**TOWN OF NEWBURGH
PLANNING BOARD
TECHNICAL REVIEW COMMENTS**

PROJECT NAME: GARDNER RIDGE
PROJECT NO.: 2-29
PROJECT LOCATION: GARDNERTOWN ROAD NEAR GIDNEY AVENUE
SECTION 75, BLOCK 1, LOT 4.12
REVIEW DATE: 27 OCTOBER 2023
MEETING DATE: 2 NOVEMBER 2023
PROJECT REPRESENTATIVE: DARREN DOCE, P.E.

Re: ***Gardner Ridge***
Gardnertown Road
Section 75, Block 1, Lot 4.12

We are submitting twelve (12) copies of the revised Amended Site Plan sheets on behalf of Gardner Ridge Associates.

SANITARY SEWER PROFILE
SCALE: 1"=4' VERT.
1"=40' HOR.

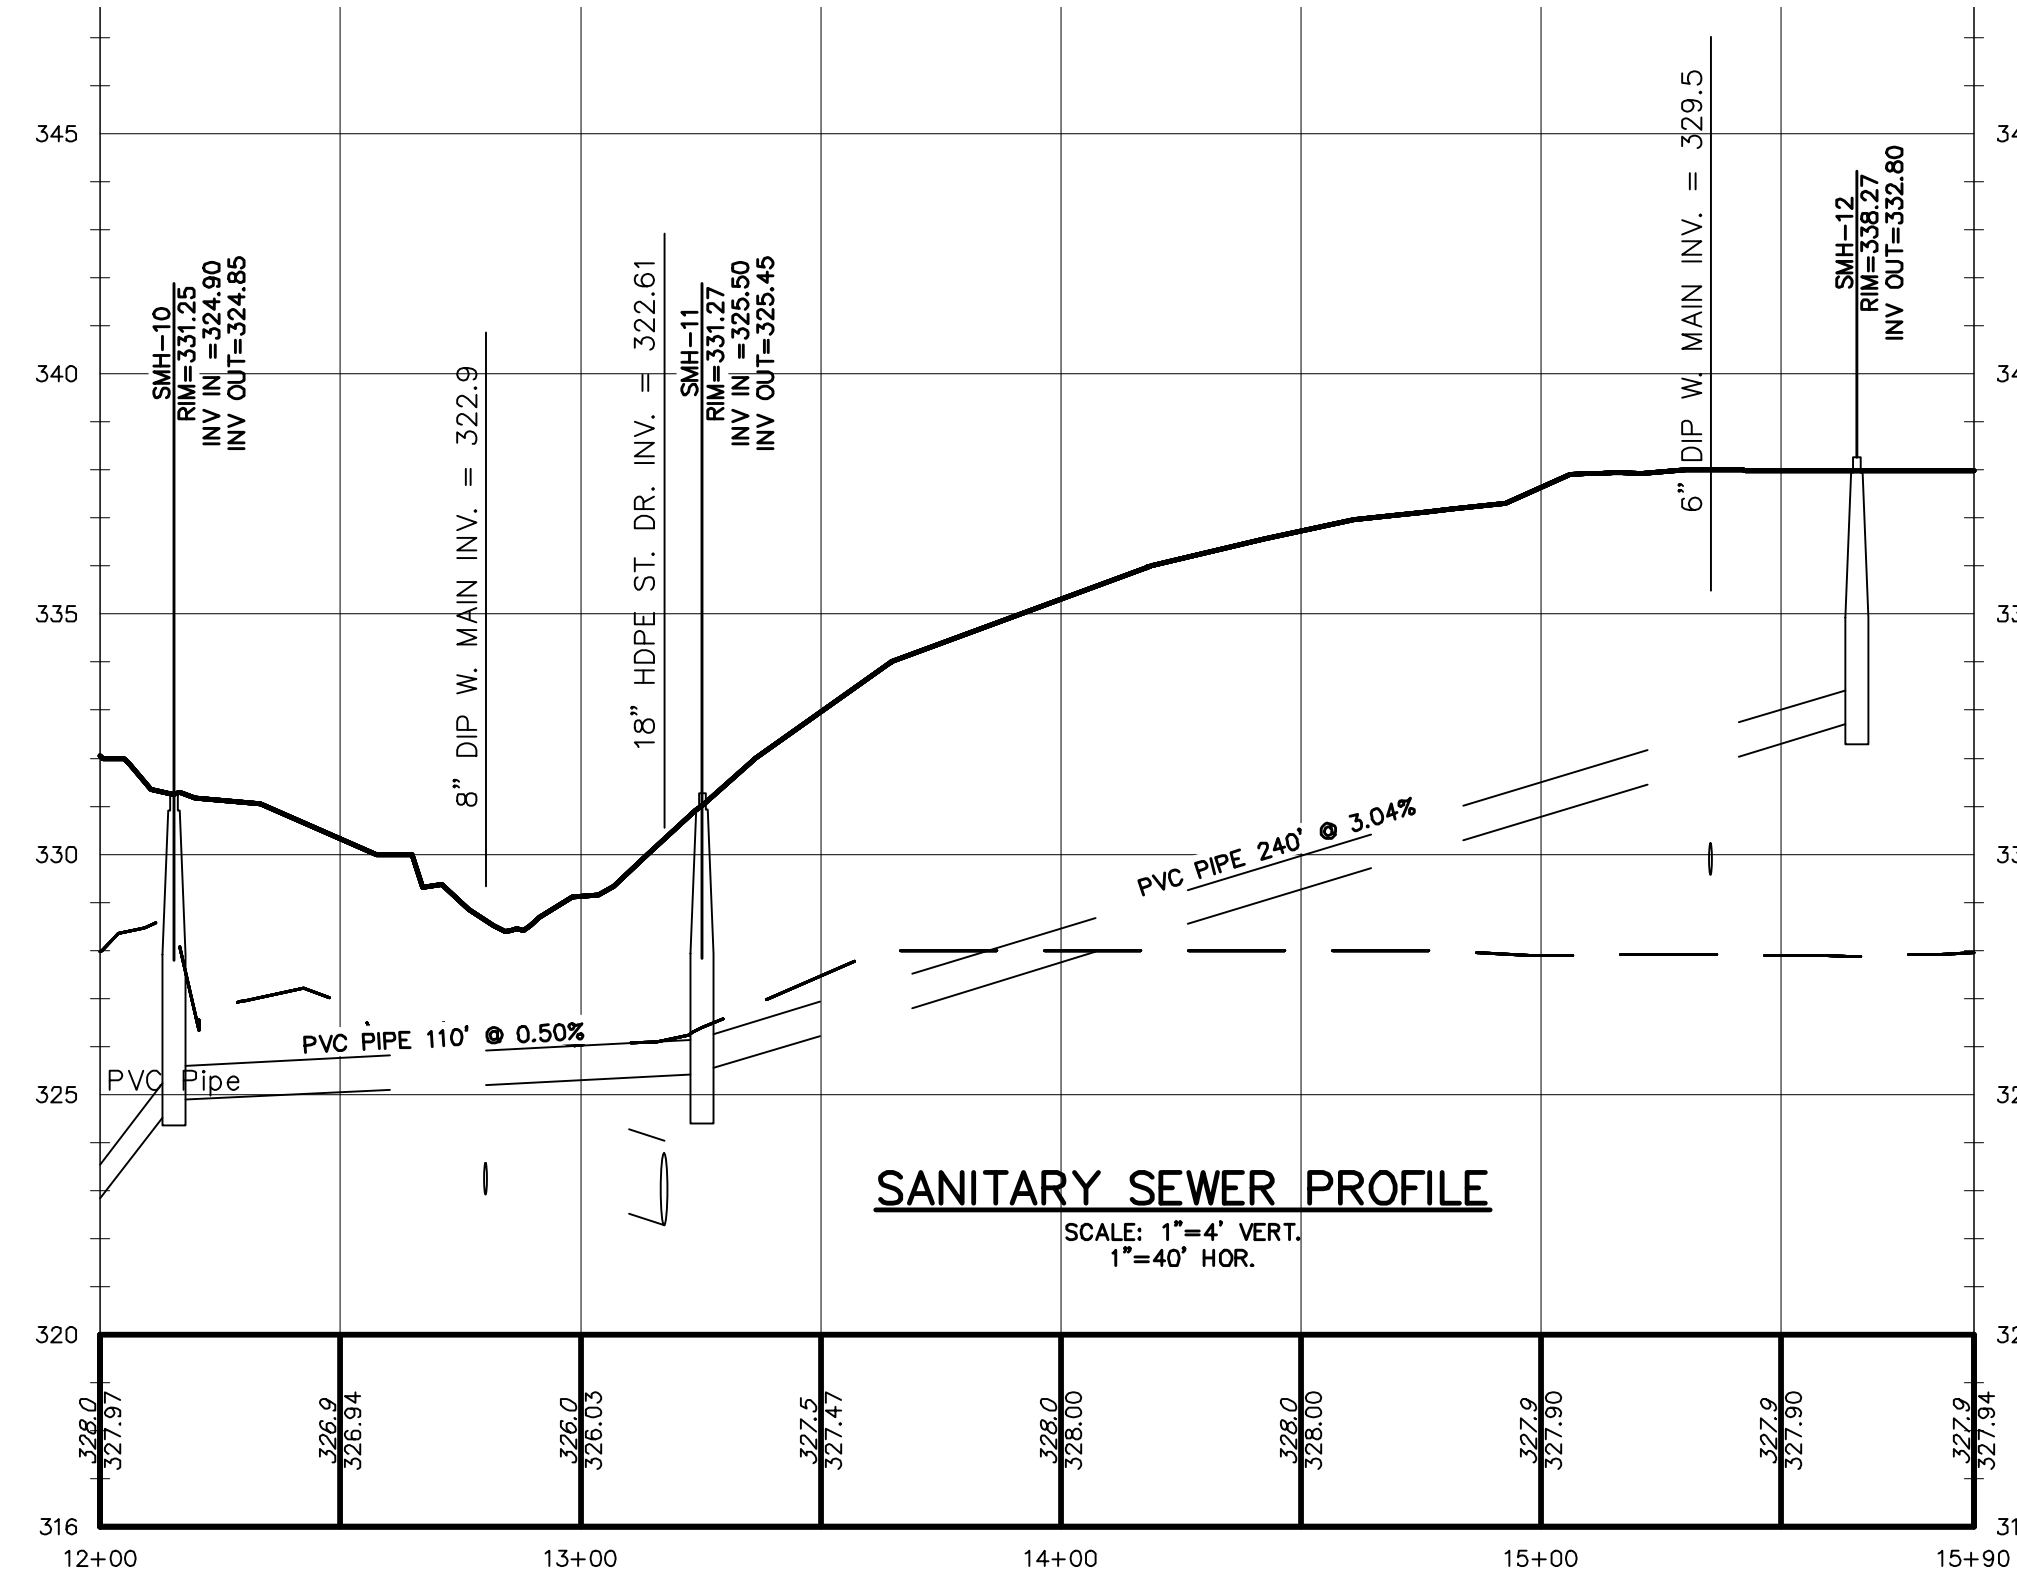
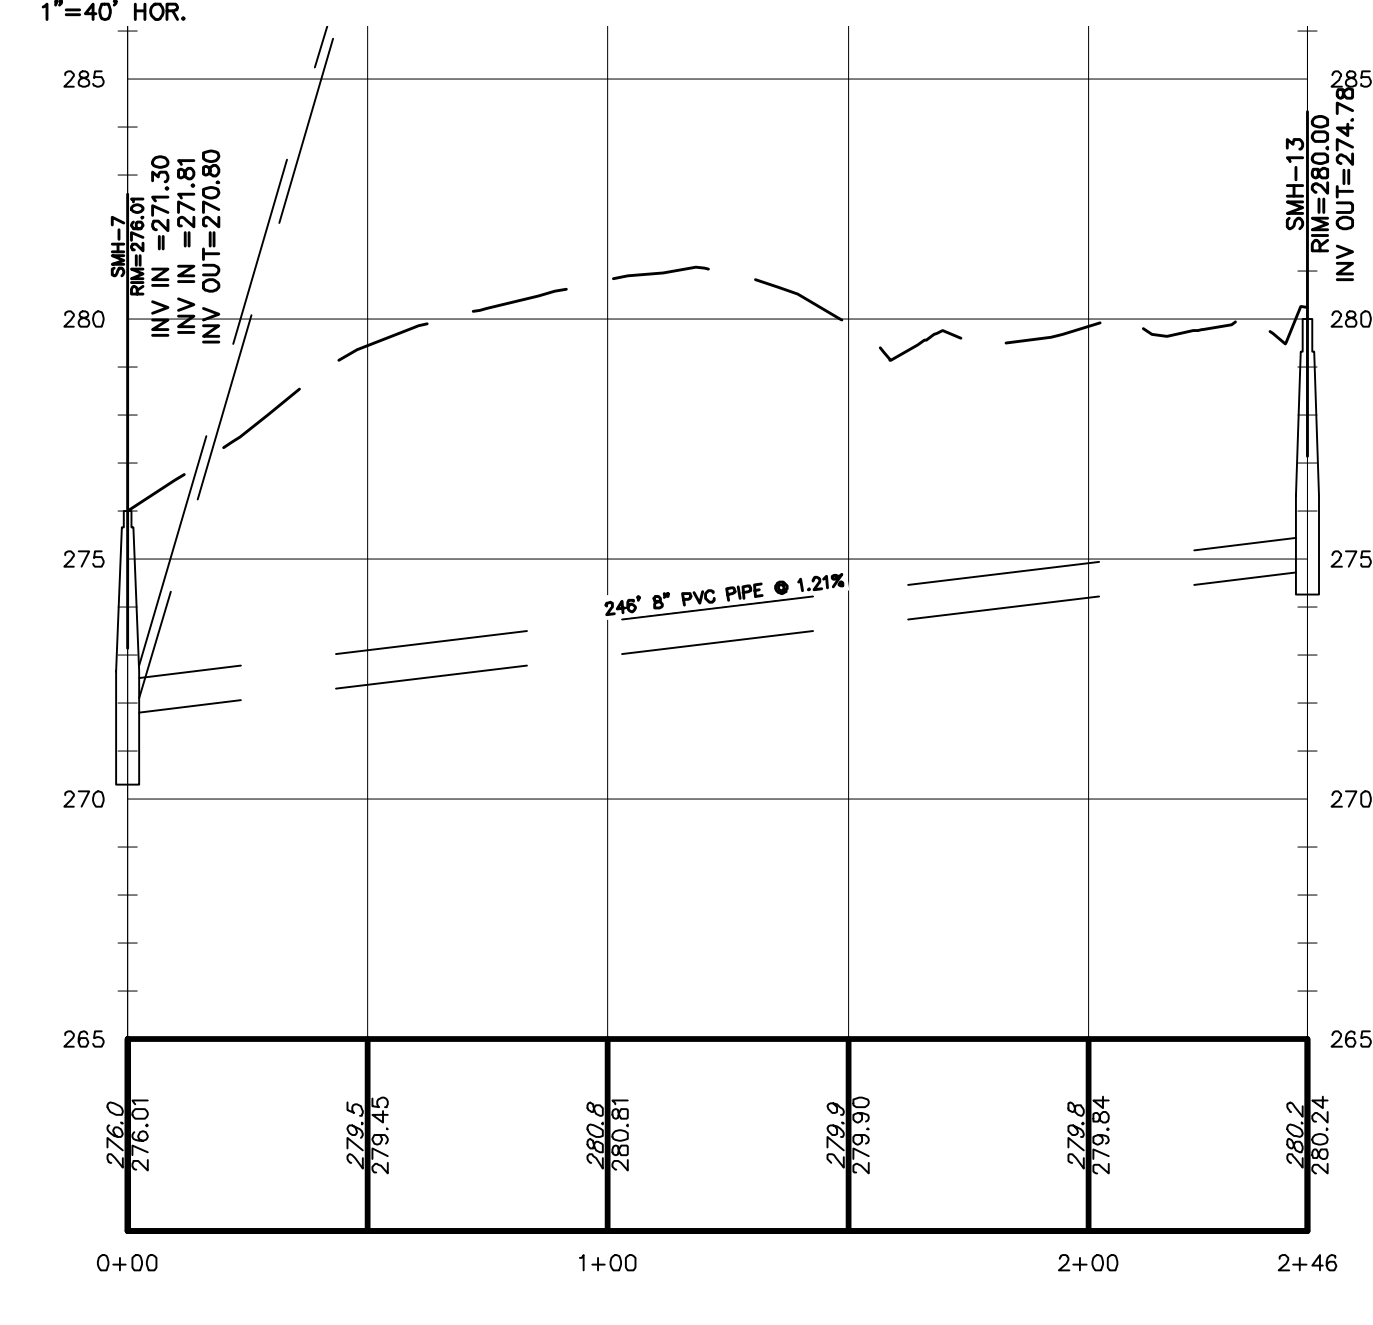
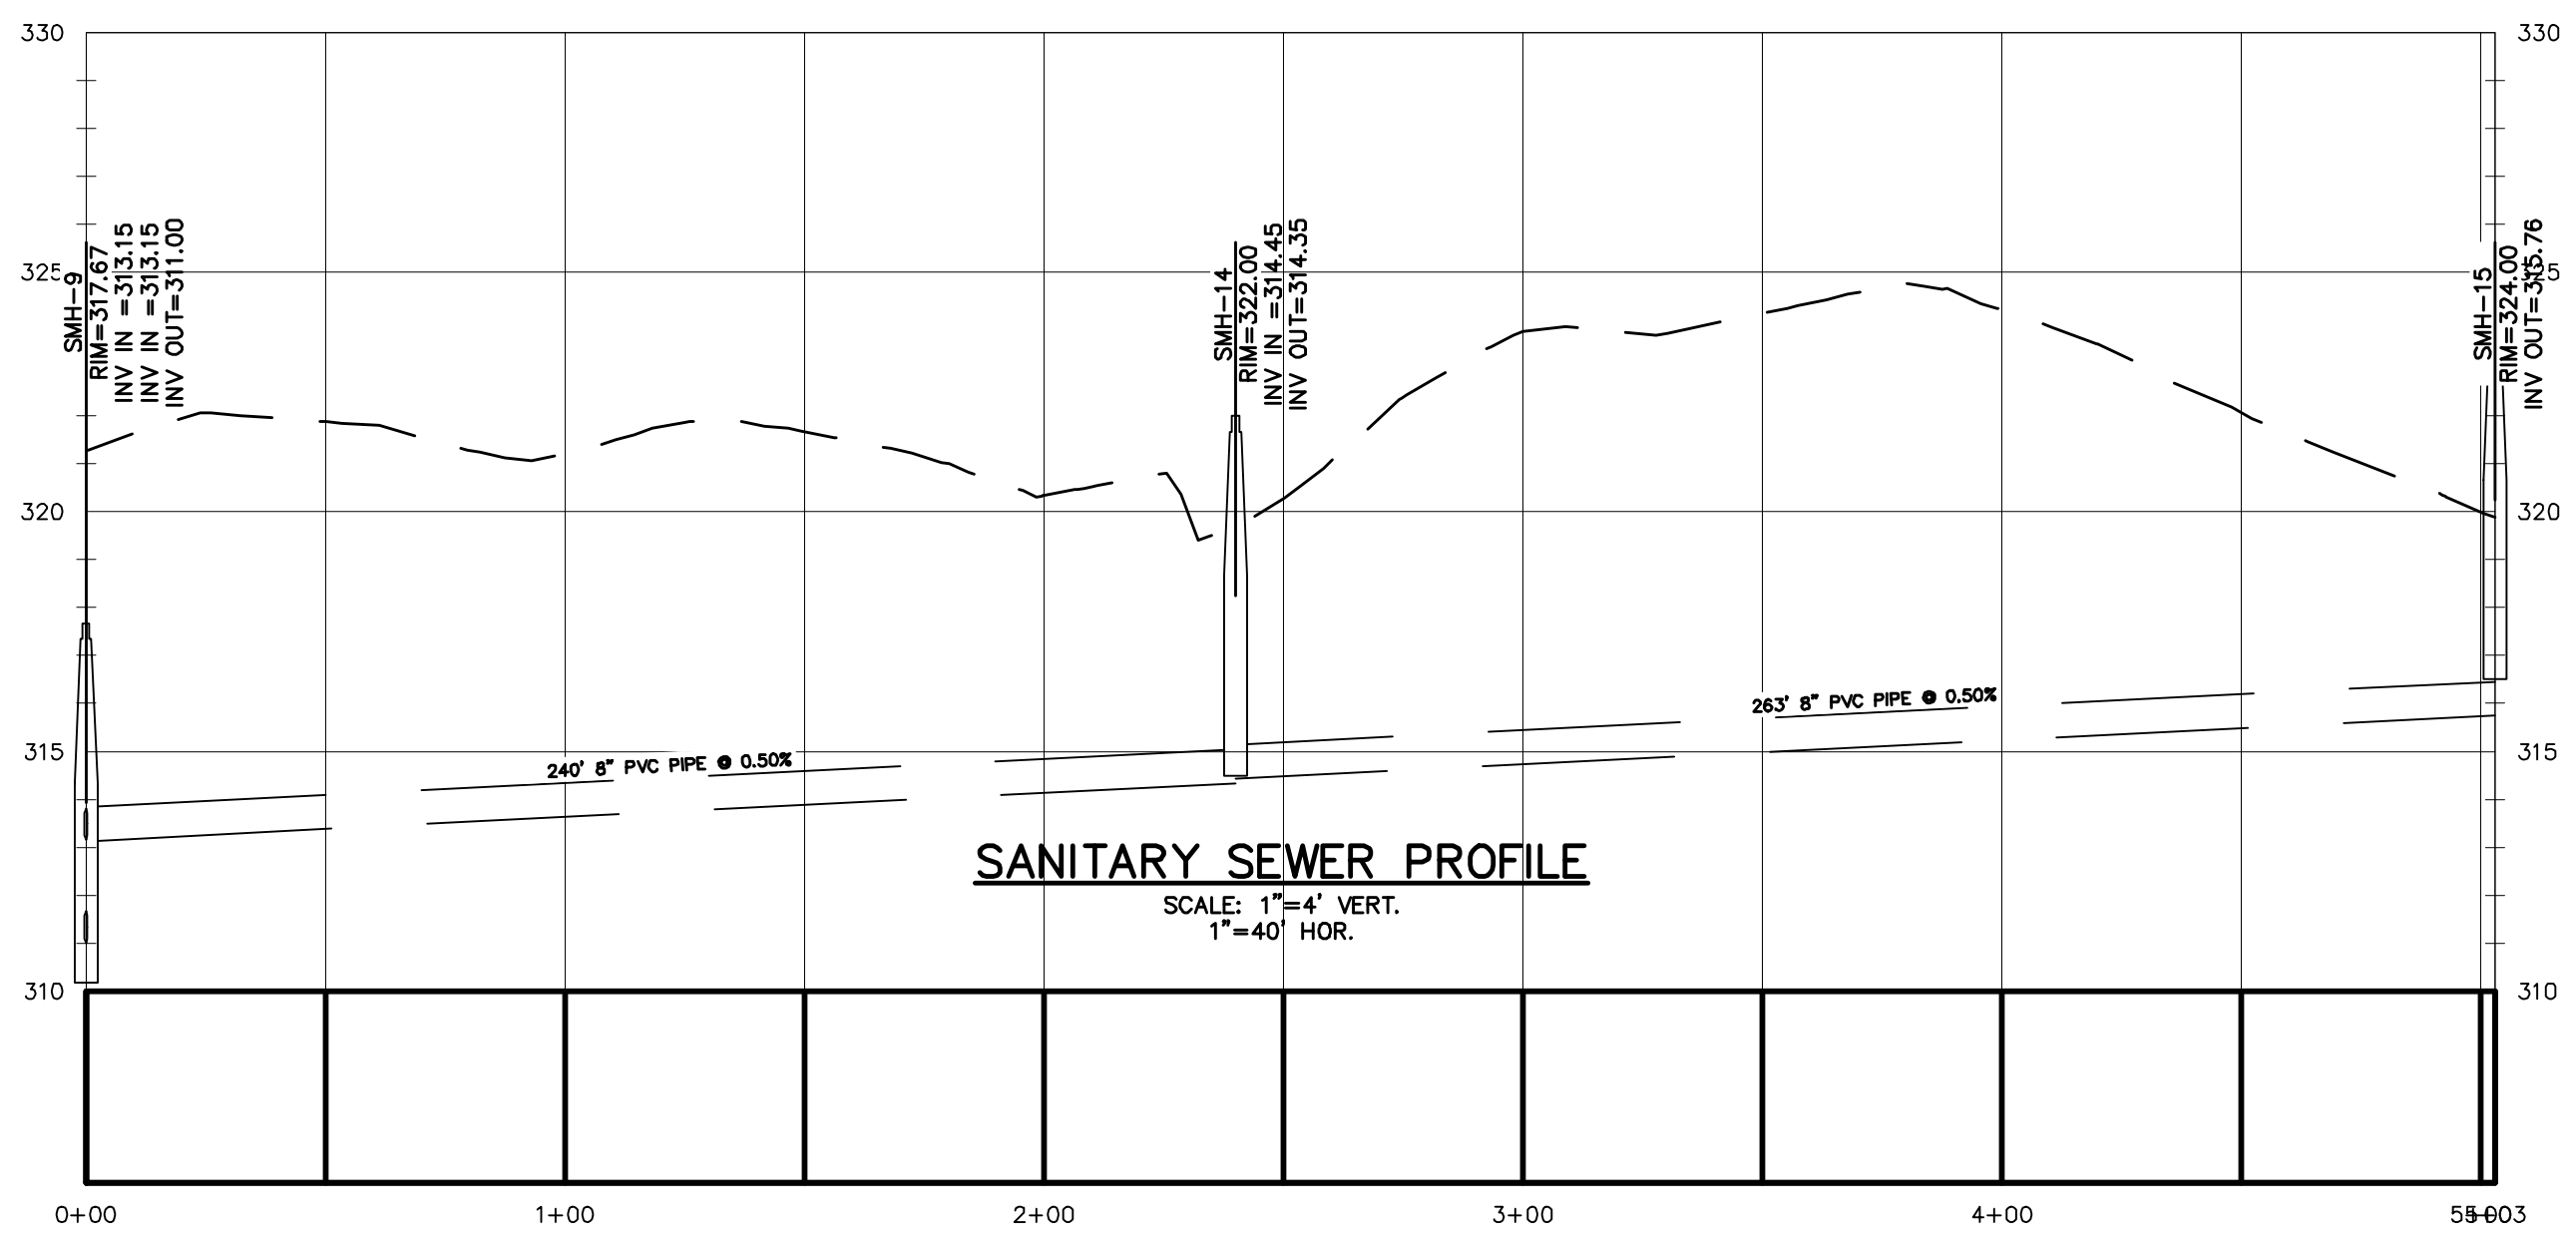
10. All Drainage and Water Main Crossings of the Sanitary Sewer Main have been added to the Profile Sheets.
11. The labels for the Sanitary sewer pipe between manholes 10 and 12 have been corrected.
